The Countryside Agency lessons learnt review of the mapping of open country and registered common land

Response by the British Mountaineering Council

- **Pallet Crag, Nr. Barnard Castle.**

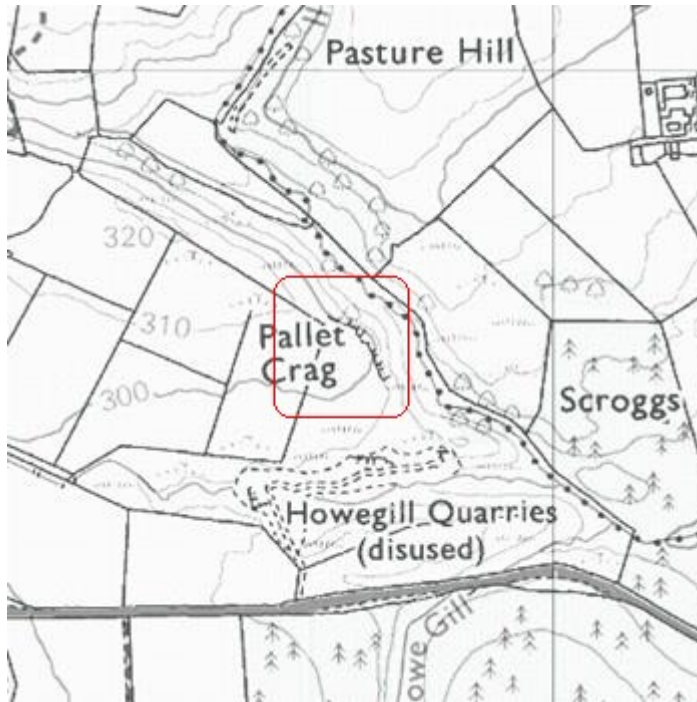
Site displays a number of qualifying criteria, not served by a PRoW - requires mapping.

- **Marske Quarry (White Scar?), Nr. Marske.**

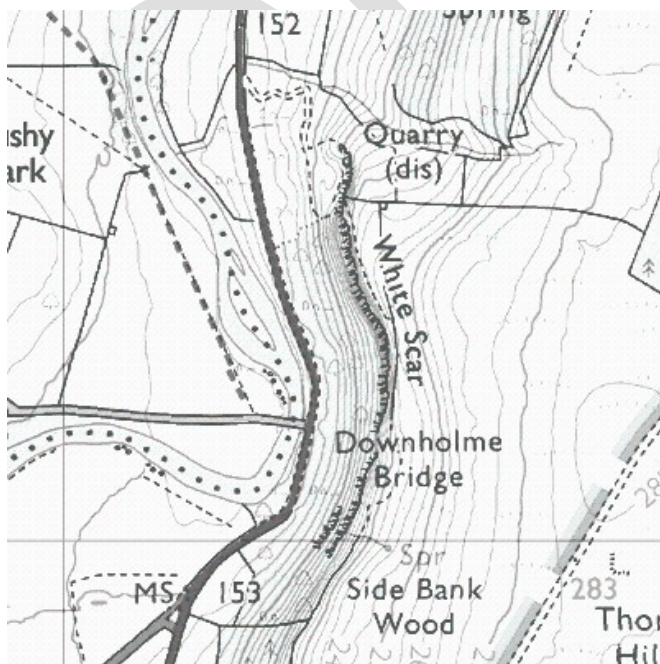
Crag displays a number of qualifying criteria and is not served by a PRoW – requires mapping.

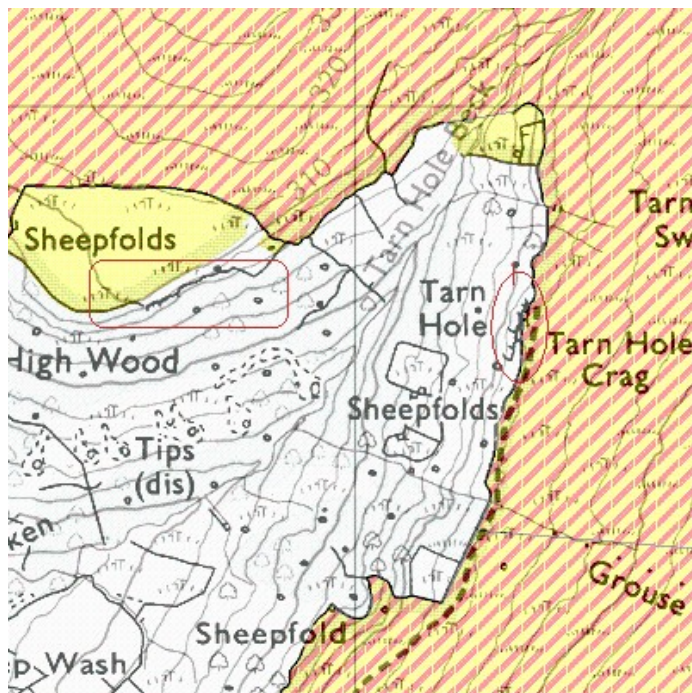
- **Tarn Hole Crag & High Crag, Tripsdale, Nr. Great Broughton.**
Inconsistent boundaries. Crags are surrounded by CRoW land but not included – requires remapping.

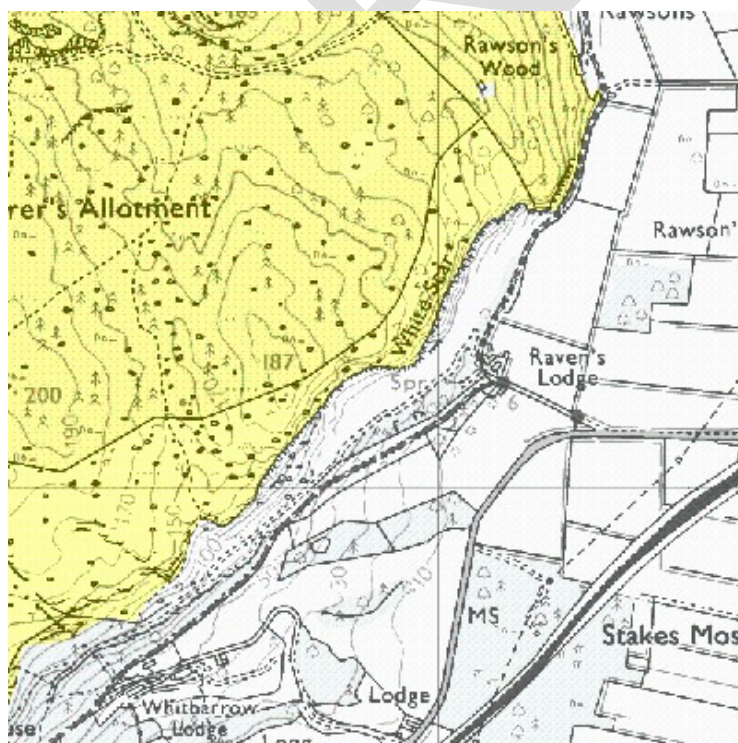
- **White Scar, Nr. Witherslack.**
Land parcel containing the crag demonstrates a number of qualifying criteria, cliff face taken as CRoW land boundary, crag not served by a PRoW – requires remapping.

- **Chapel Head Scar, Witherslack.**

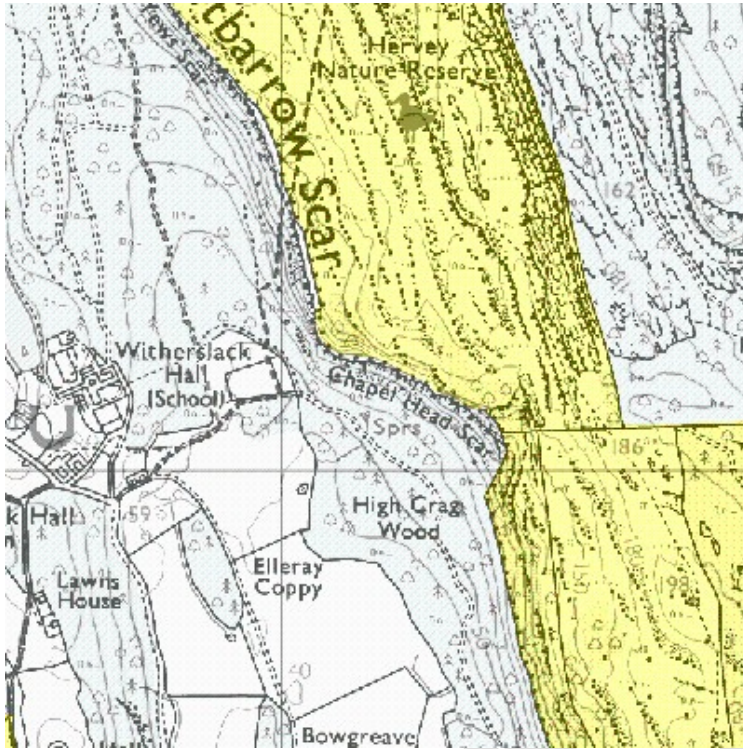
Crag face mapped as the boundary of CRoW land – requires remapping.

- **Tongue Scar & boulders, Kentmere.**

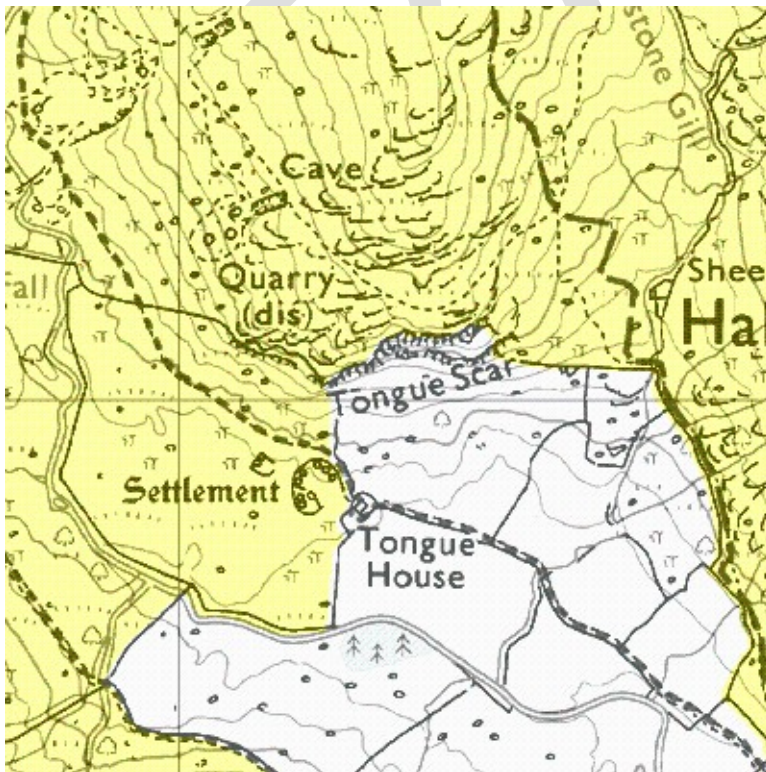
Crag not served by a PRow, crag face used as boundary of CRoW land, access banned (and enforced) by landowner - requires remapping.

- **Black Crag, Borrowdale.**

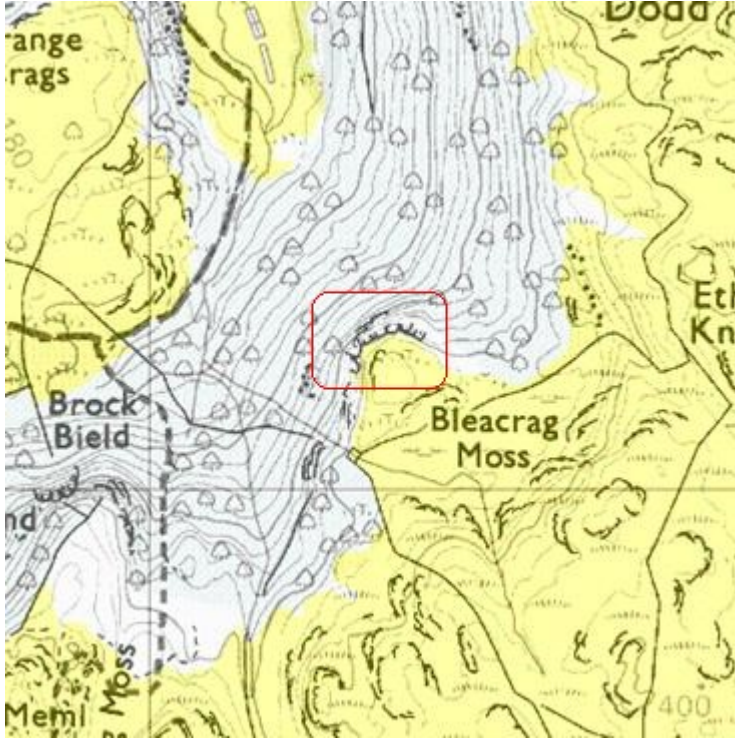
Crag face not included on CRoW land or served by a PRoW – requires remapping.

- **Bowderstone Crag, Borrowdale.**

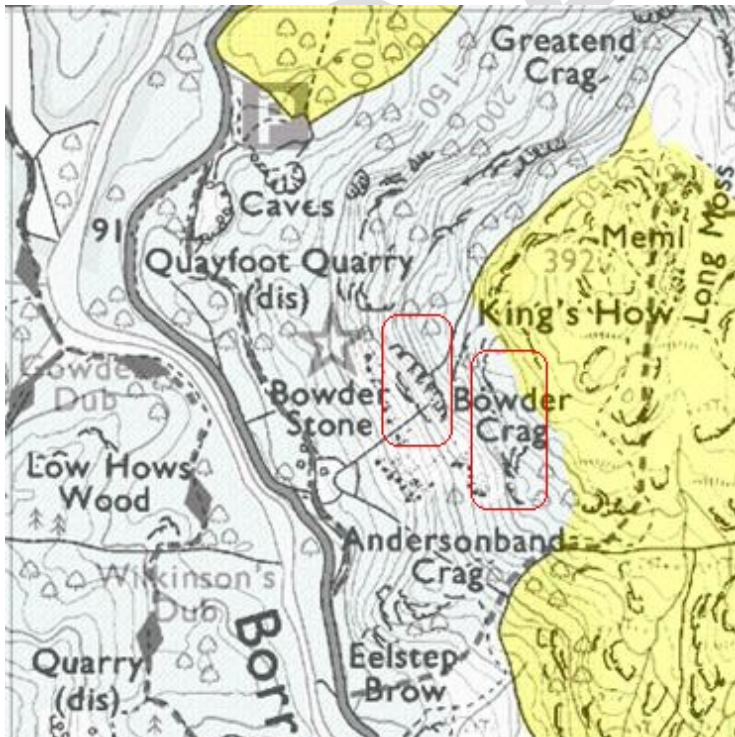
Crag and Bowder Stone display a number of qualifying criteria – requires mapping.

- **Windmore End, Nr. Brough.**

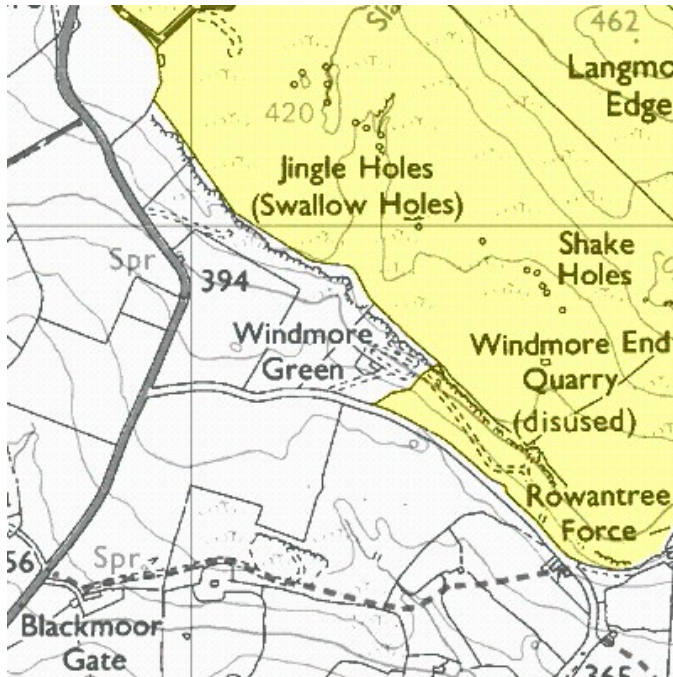
Inconsistent mapping. SE half of the escarpment is situated on CRoW land, the remainder is not despite being situated on land of comparable character – requires remapping.

- **Peel Crag & Crag Lough, Nr. Redburn.**

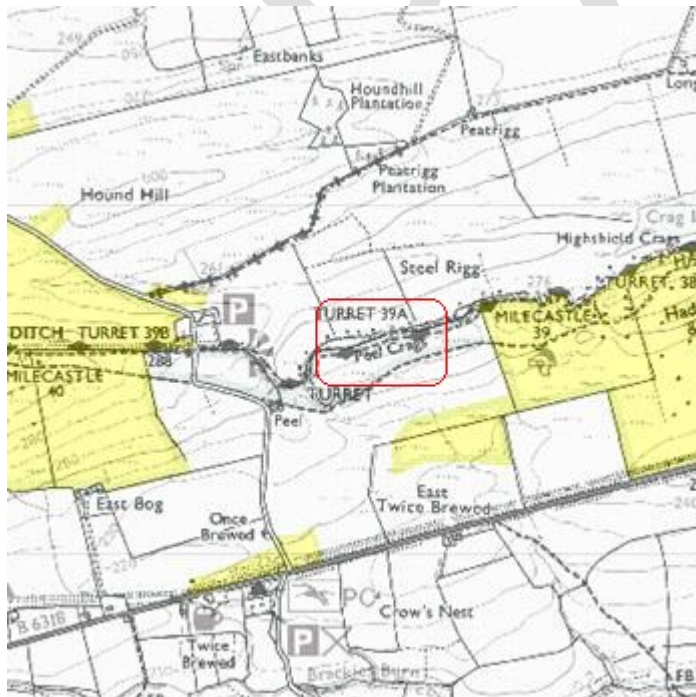
The land parcel demonstrates a number of qualifying criteria, it is also surrounded by CRoW land of comparable character – requires remapping.

- **Kyloe Crag (Collar Heugh), Nr. Lowick.**

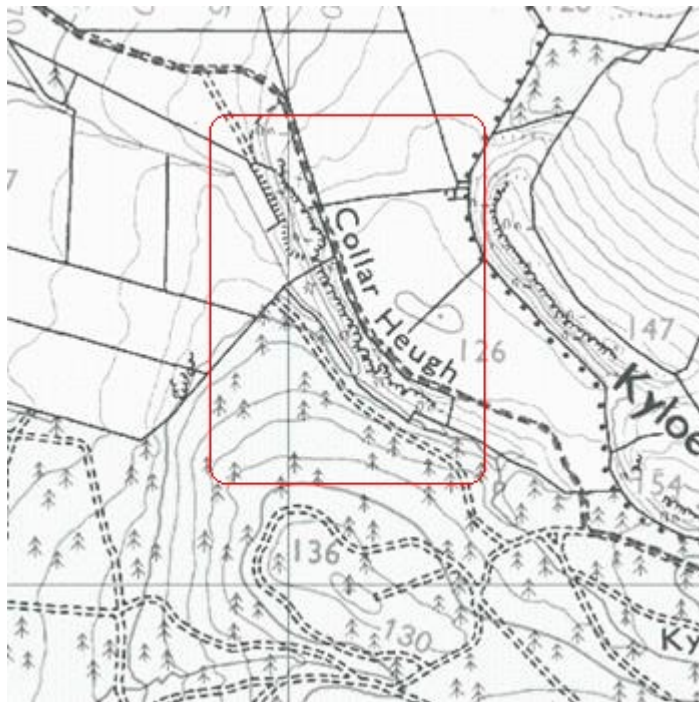
Crag is served by a PRow but also demonstrates a number of qualifying criteria – requires mapping.

- **Back Bowden Doors (Colour Heugh), Nr. Belford.**

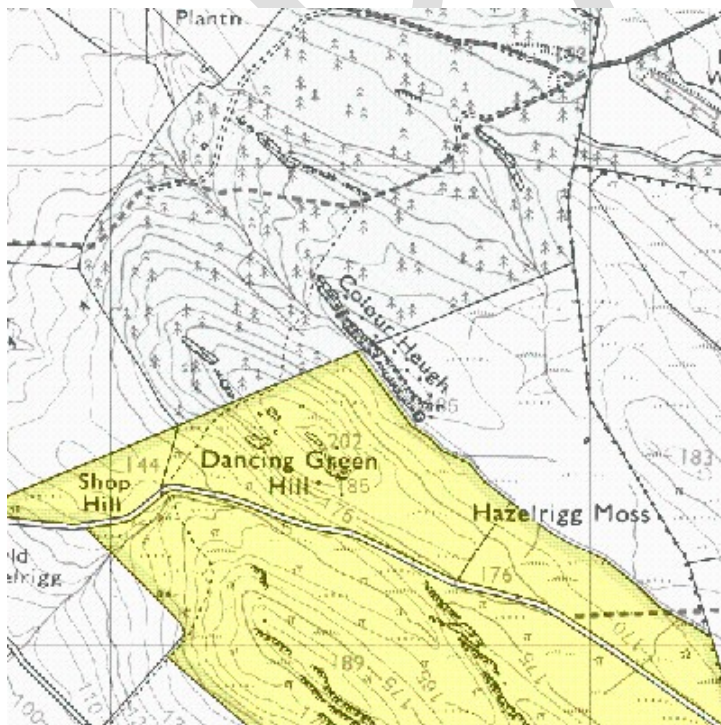
Significant proportion of crag demonstrates qualifying criteria – requires mapping.

- **Running Hill Pits**

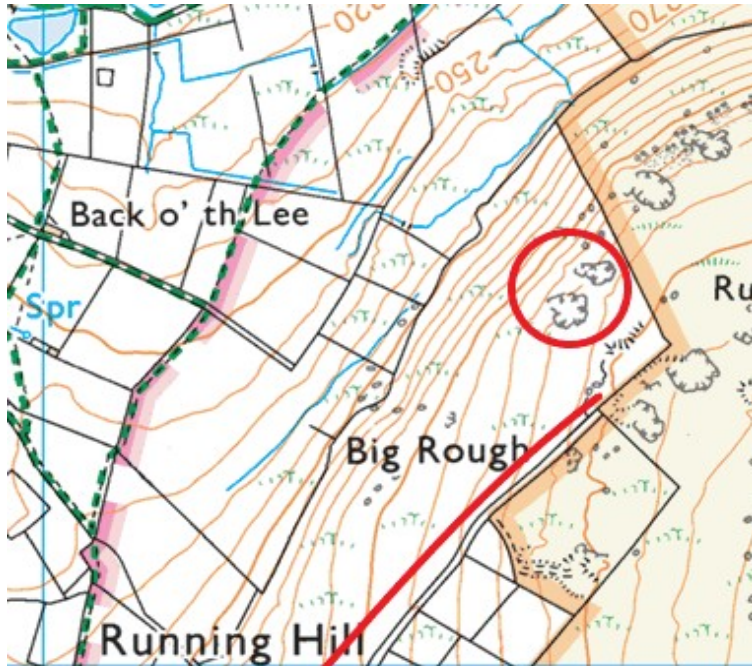
Quarry No 7 & 8 are not on open access land whereas all the other quarries in this complex are mapped. The most obvious means of access is to use the non-ROW track leading from the marked parking to the quarries along the red line – this is not access land and nor is it a right of way so technically there is no legal right to use it. Liaising with farmer for voluntary access has proved difficult.
